Project	IEEE 802.16 Broadband Wireless Access Working Group < <a href="http://ieee802.org/16">http://ieee802.org/16</a> >	
Title	Clean-up of OFDMA Numerology, TTG/RTG, and Irregular Subframe in IEEE 802.16m AWD	
Date Submitted	2009-03-02	
Source(s)	Jaeweon Cho, Hokyu Choi, Samsung Electronics Co., Ltd.	+82-31-279-5796 <a href="mailto:jaeweon.cho@samsung.com">jaeweon.cho@samsung.com</a>
	Sassan Ahmadi Intel Corporation	<a href="mailto:sassan.ahmadi@intel.com">sassan.ahmadi@intel.com</a>
	Sungho Moon, Jin Sam Kwak LG Electronics	<a href="mailto:msungho@lge.com">msungho@lge.com</a>
Re:	"802.16m AWD" IEEE 802.16m-09/0012, "Call for Contributions on Project 802.16m Amendment Working Document (AWD) Content" – Call for Comments on Amendment Working Document.	
Abstract	This contribution proposes to change OFDMA numerology, TTG/RTG lengths, and irregular subframe structure in the current IEEE 802.16 AWD, in order that they should be aligned with those in the current IEEE 802.16 SDD.

# Clean-up of OFDMA Numerology, TTG/RTG, and Irregular Subframe in the IEEE 802.16m AWD

Figure 391 Frame Structure with type-1 and type-3 subframes in TDD duplex mode for 5, 10, 20 MHz channel bandwidths ( $CP=1/8 T_b$ )

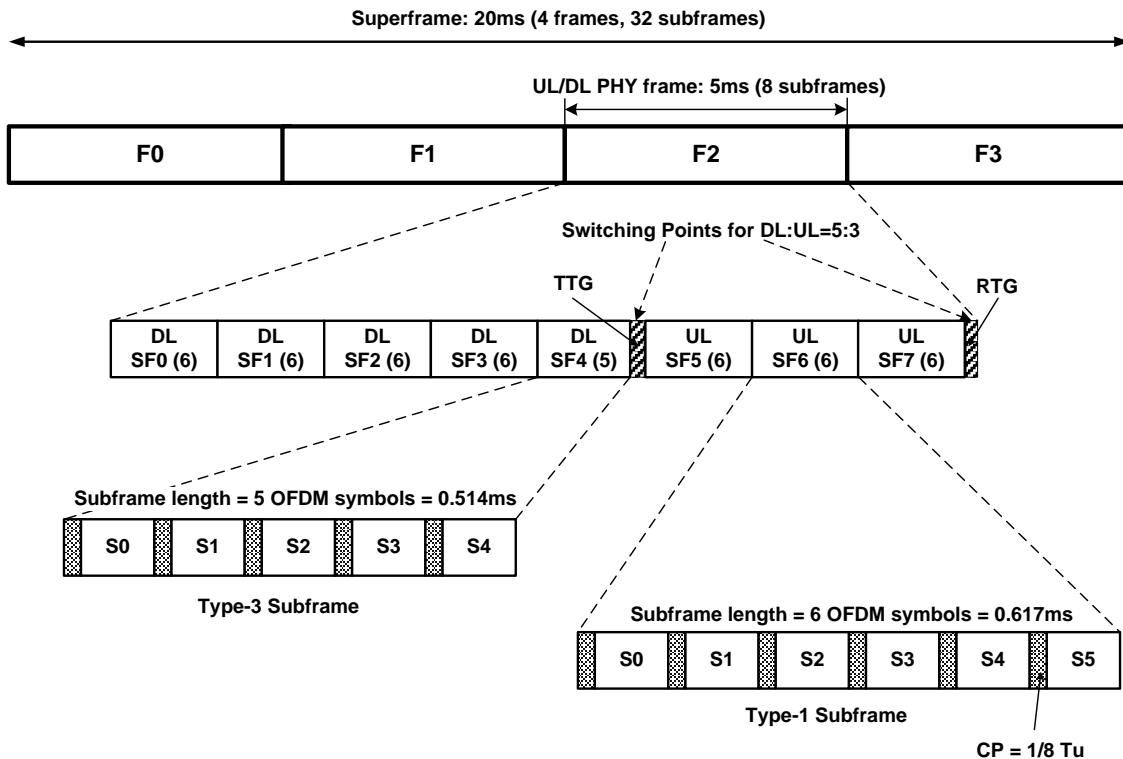
Figure 391 illustrates an example TDD frame structure with D:U = 5:3, which is applicable to the nominal channel bandwidths of 5, 10, and 20 MHz with  $G = 1/8$ . In Figure 391 the last DL subframe, i.e. DL SF4, is a type-3 subframe and the other subframes are type-1 subframes. TTG and RTG are 105.714  $\mu$ s and 60 $\mu$ s, respectively.

[Remedy 4: Replace Figure 391 in page 17 with the following Figure]

Figure 392 TDD and FDD Frame Structure with CP of  $1/16 T_b$  (DL to UL ratio of 5:3)

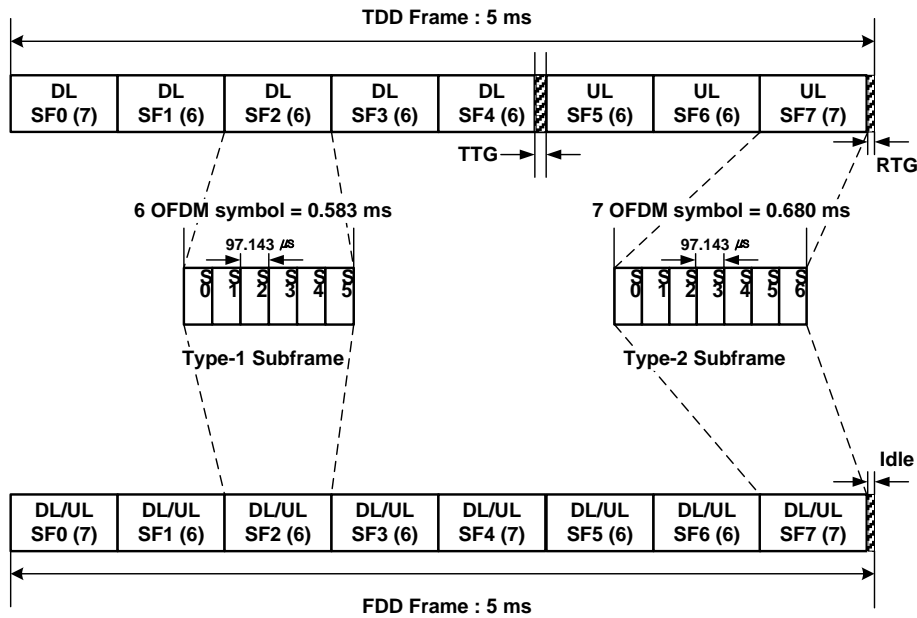
Figure 392 illustrates an example of TDD and FDD frame structure with a CP of  $1/16 T_b$ . Assuming OFDMA symbol duration of  $97.143 \mu s$  and a CP length of  $1/16 T_b$ , the length of type-1 and type-2 subframes are 0.583 ms and 0.680 ms, respectively. TTG and RTG are  $82.853 \mu s$  and  $60 \mu s$ , respectively.

[Remedy 6: Replace Figure 392 in page 18 with the following Figure]
